VERSION 2

BINARY INPUT INTERFACE TOP LEVEL

D1001036
aLIGO
Version 2

64 Channel Binary Input Card

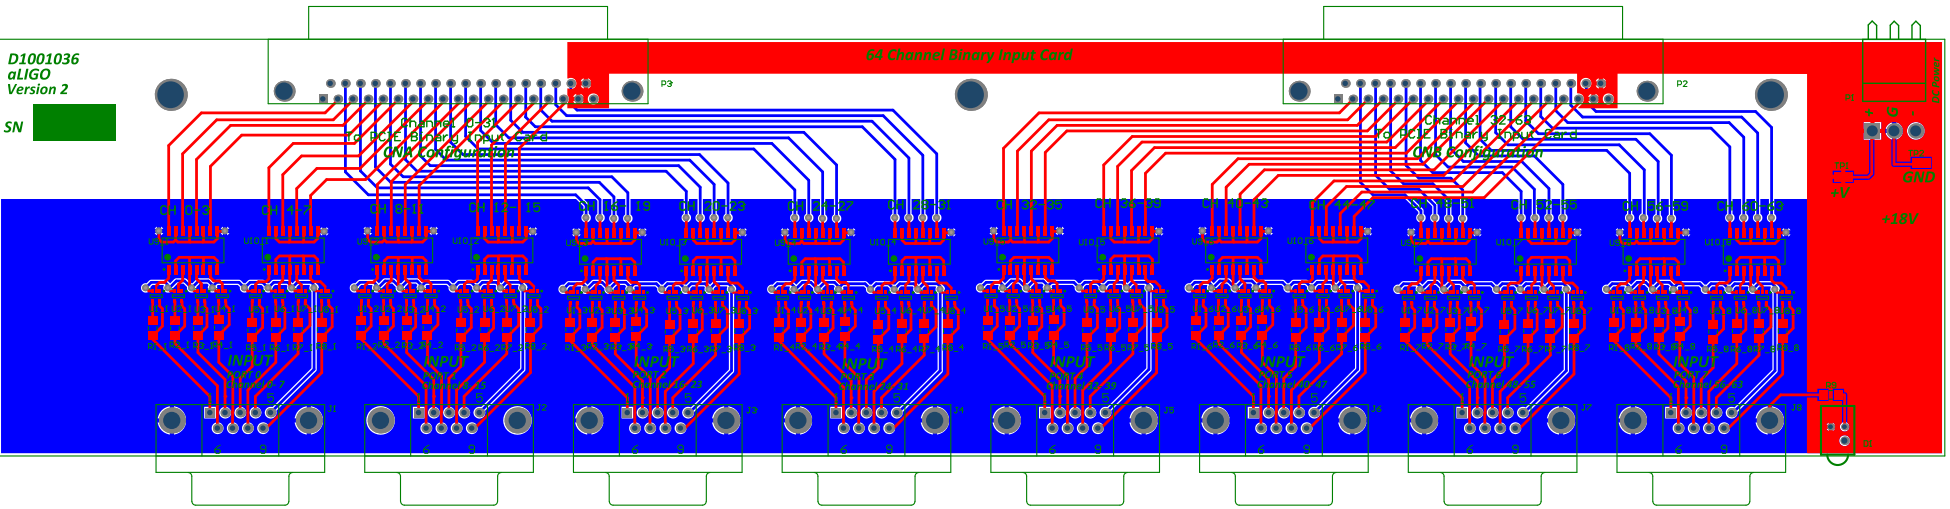
NOTES
VC CHANGES
Corrected mounting hole to plated through holes
Added pull back on poly plane points on top and bottom
Increased text width on silkscreen from 1 to 7 mill thickness
Added channel identification onto silkscreen
Change board size from 16" to 14" wide
Change footprint size from 0805 to 1206, for R9
